Access Compliance Report

Public Rights-of-Way

Intersection ID: 14552	Main Street: BAXTER_ST	Cross Street: AVANT_ST	Location: NE
ADA ID: 06BC193B254E	Ramp Type: PerpDiag	Initial Pass/Fail: Fail	Overall Compliance: No
		Severity Score: 12.5

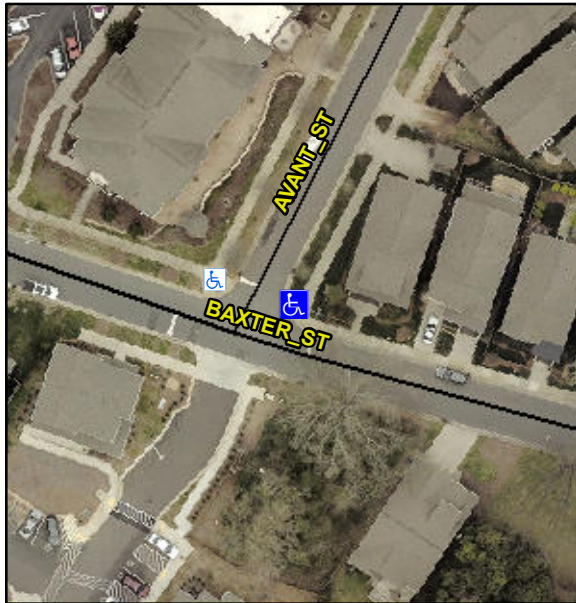
Not Found, R304.5.3

Compliance	Description	Data	Compliance	Description	Data
N/A	Ramp Length (in)	59.0	Yes	Ramp Slope (%)	5.1
Yes	Ramp Width (in)	48.0	No	Ramp XSlope (%)	6.4
N/A	Flare Type LT	N/A	N/A	Flare Type RT	N/A
N/A	Flare Slope LT (%)	N/A	N/A	Flare Slope RT (%)	N/A
N/A	Flare Traversable LT?	N/A	N/A	Flare Traversable RT?	N/A
N/A	Landing Length (in)	N/A	N/A	DWS Provided?	N/A
N/A	Landing Width (in)	N/A	N/A	DWS Contrast?	N/A
N/A	Landing Slope (%)	N/A	N/A	DWS Length (in)	N/A
N/A	Landing X Slope (%)	N/A	N/A	DWS Full Width?	N/A
N/A	Landing Curb? (Y/N)	N/A	N/A	DWS Offset (in)	N/A
N/A	Shared Landing?	N/A			
N/A	Gutter Ponding?	N/A	N/A	Gutter Slope (%)	N/A
N/A	Gutter Lip Ht (in)	N/A	N/A	Gutter X Slope (%)	N/A
N/A	Painted X Walk1?	No	N/A	Painted X Walk2?	No
	X Walk 1 Direction	To NW		X Walk 2 Direction	To SW
N/A	X Walk 1 Width (in)	N/A	N/A	X Walk 2 Width (in)	N/A
	X Walk 1 Slope (%)	0.5		X Walk 2 Slope (%)	1.1
	X Walk 1 X Slope (%)	6.1		X Walk 2 X Slope (%)	1.4

Remove & Replace Curb Ramp With Two New Directional Ramps or Equivalent.
